Staff Report

Re: Petition PLNHLC2017-00722, TAG Row House Development

NEW CONSTRUCTION – 3-UNIT ROW HOUSE

PROPERTY ADDRESS: 613 East 100 South

A200

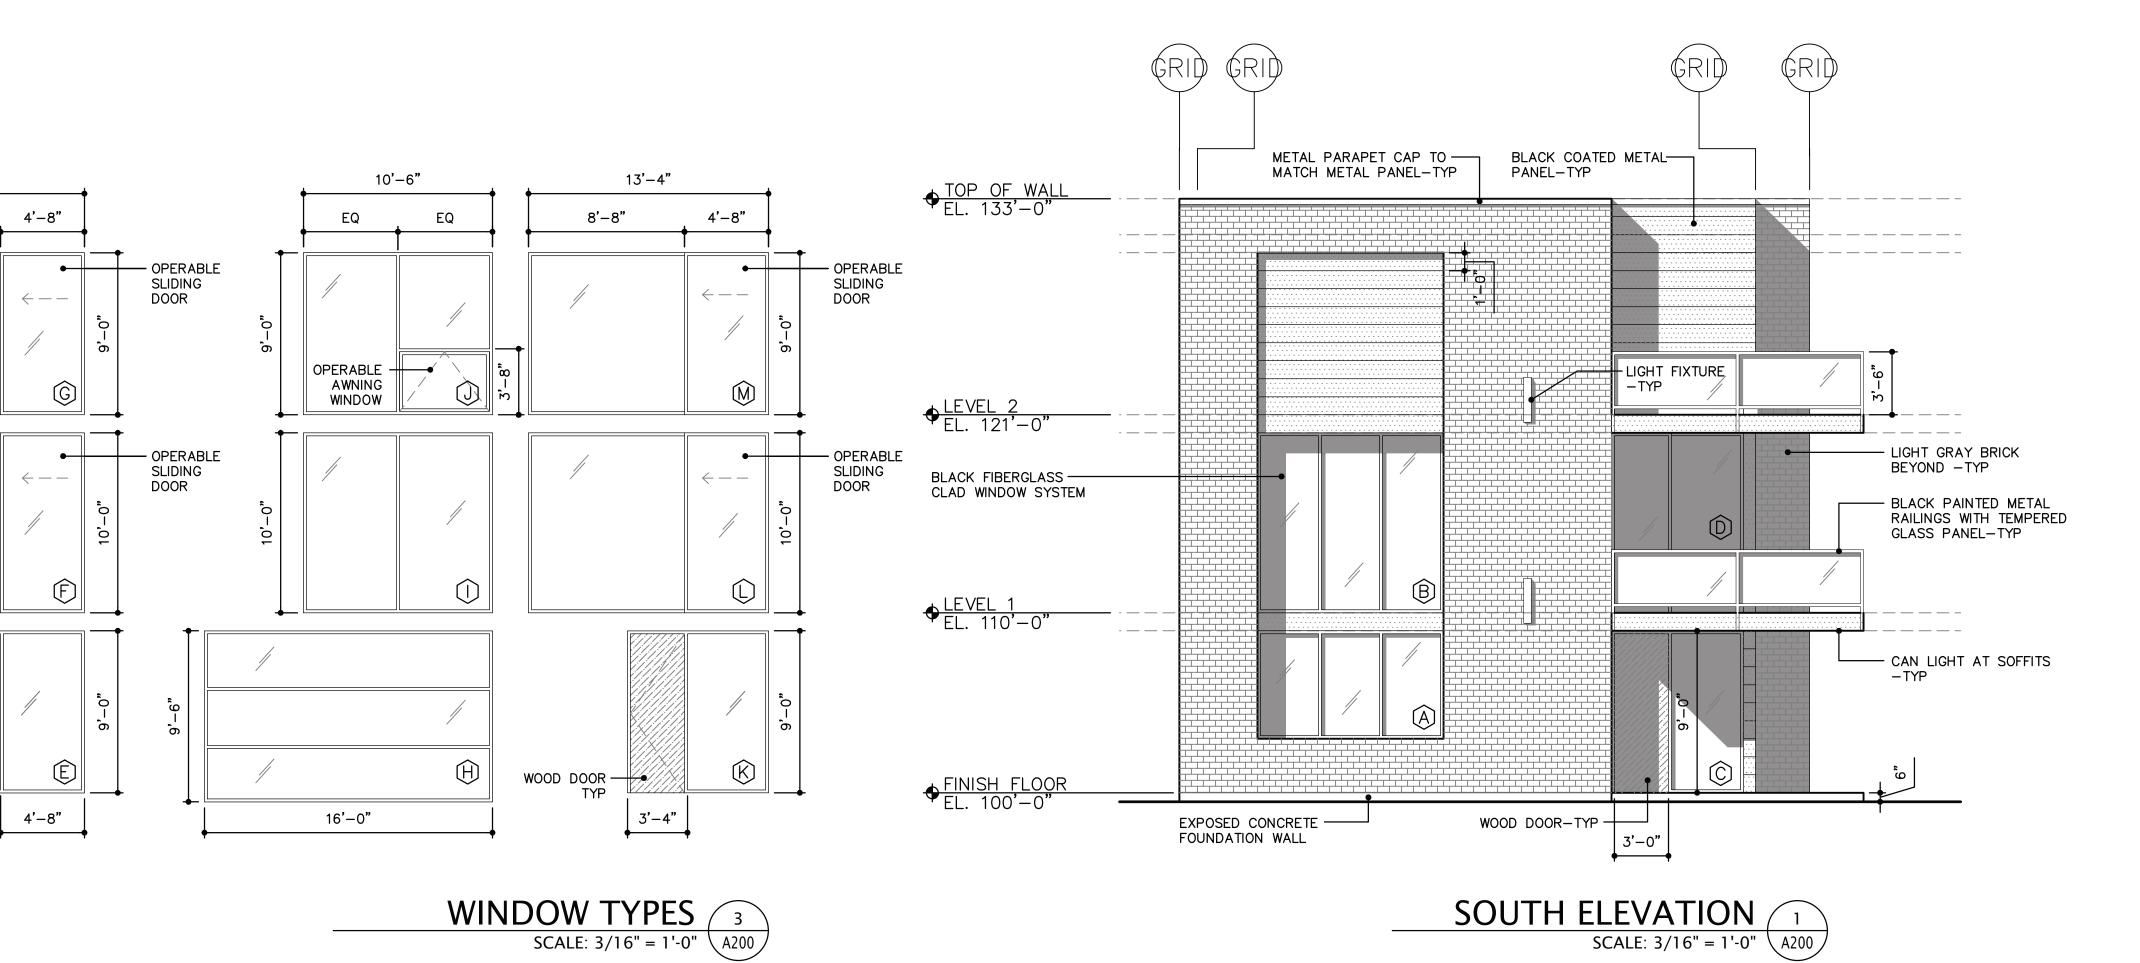
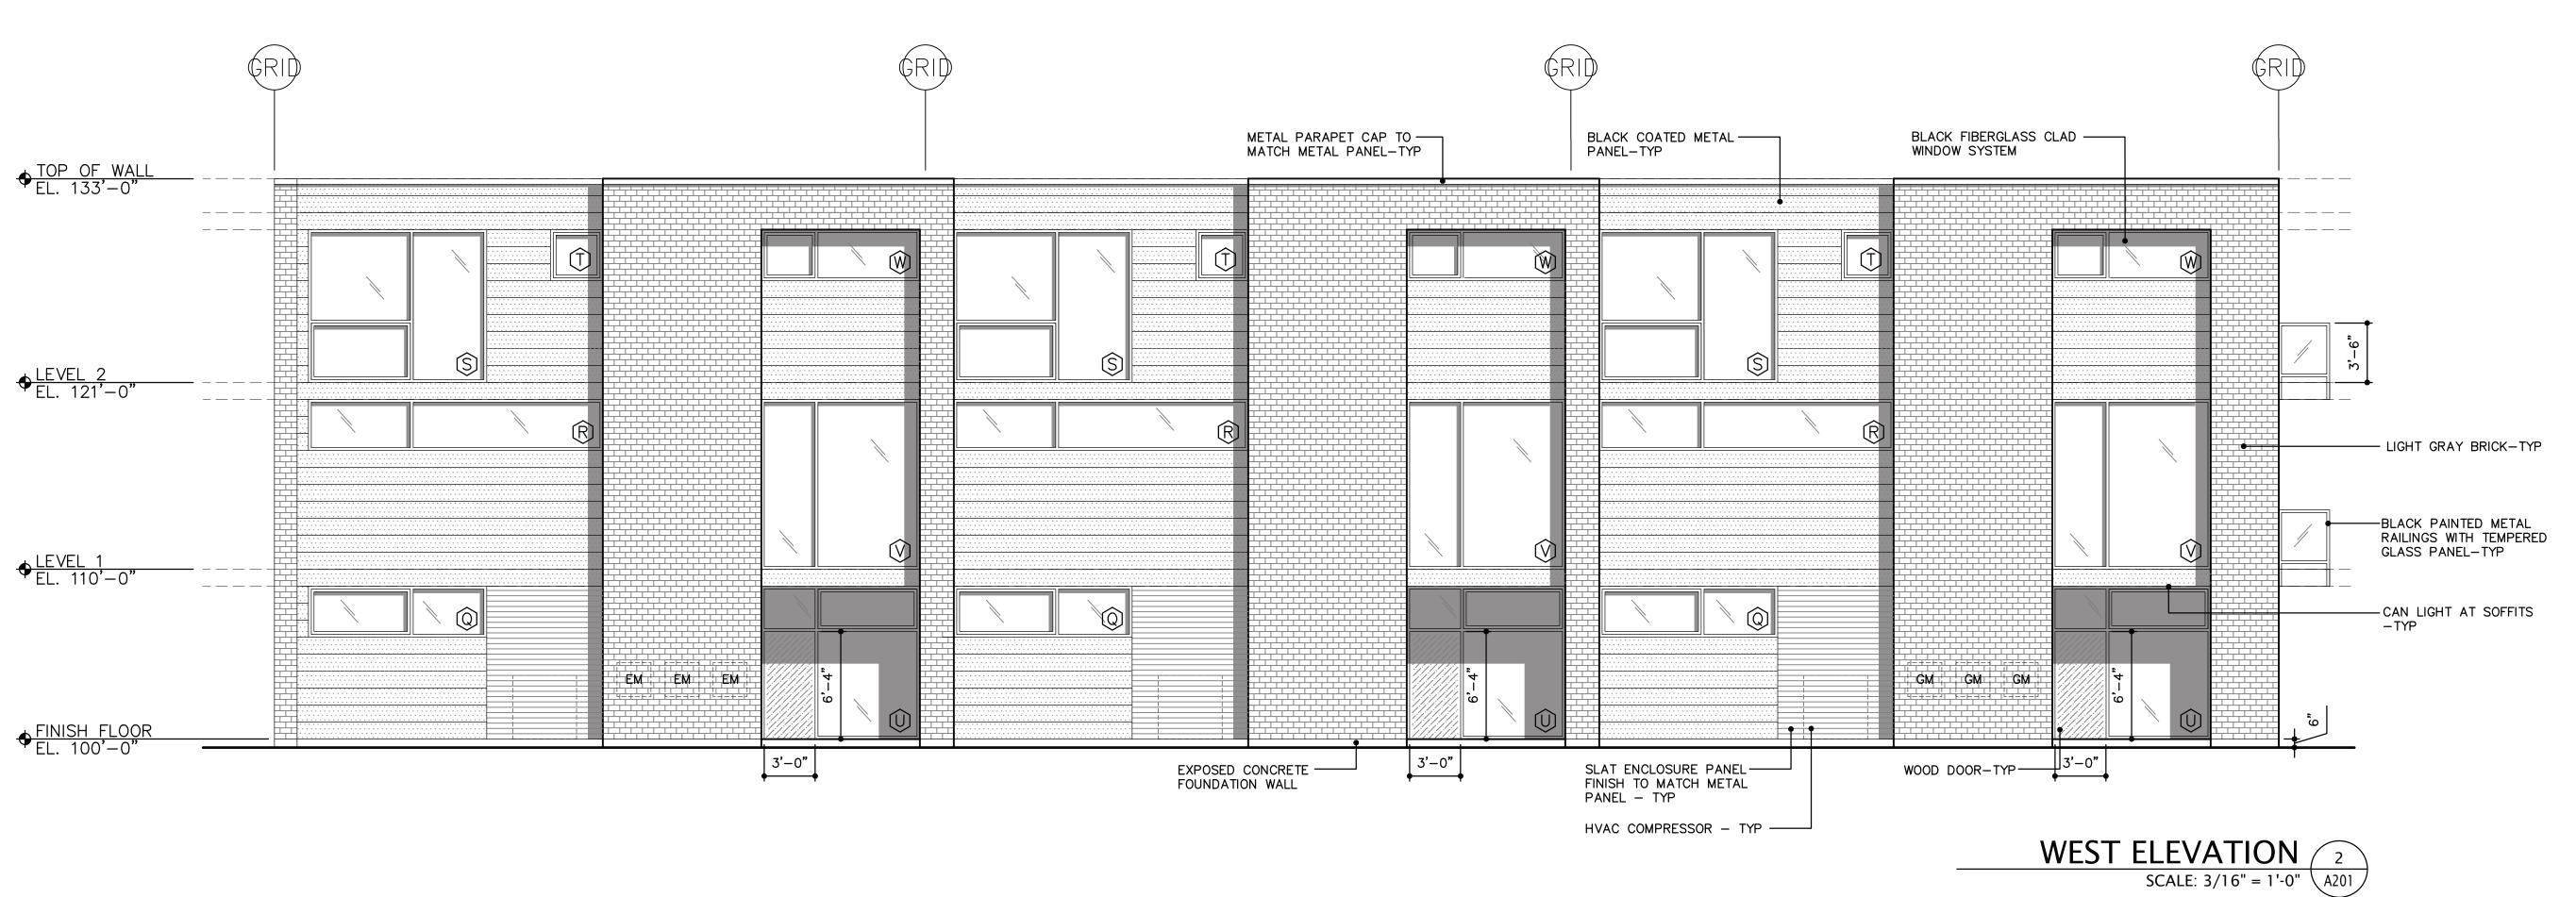
- The feeling of a larger mass and the overall scale of the building has been visually reduced on the south elevation. This has been achieved by reducing the width of the brick volume to 24'-0" from the previous 35'-0". The column on the south-east corner balcony has also changed to a steel column from a masonry column. This reduced the width of the column from 3'-8" to 8". As demonstrated on sheet A001 the south elevation of this building now falls within the average width to height ratio of the surrounding buildings (Refer to A001, A200 & A201)

The front entryway has been pronounced by centering the opening with the main approach and increasing the height of the front door to 9' from the previous 7'. The approach sequence to the front doors will begin at the base of the park strip, where the existing historic stepping stone will be relocated and preserved. Much like the surrounding context, this project contains a front entry which is covered. This covering indicates the place of entry for the residence and creates protection from the elements throughout the year. The front entry and the soffit protecting it will be made of stained plain sawn cherry wood. This natural material will contrast the brick and metal envelope as a material extension from the interior to the exterior. At night the entries to the building will be illuminated by recessed can lights within the soffit for added safety and to further indicate entry. (Refer to wood sample, can light cut sheet, A001, A200 & A201)
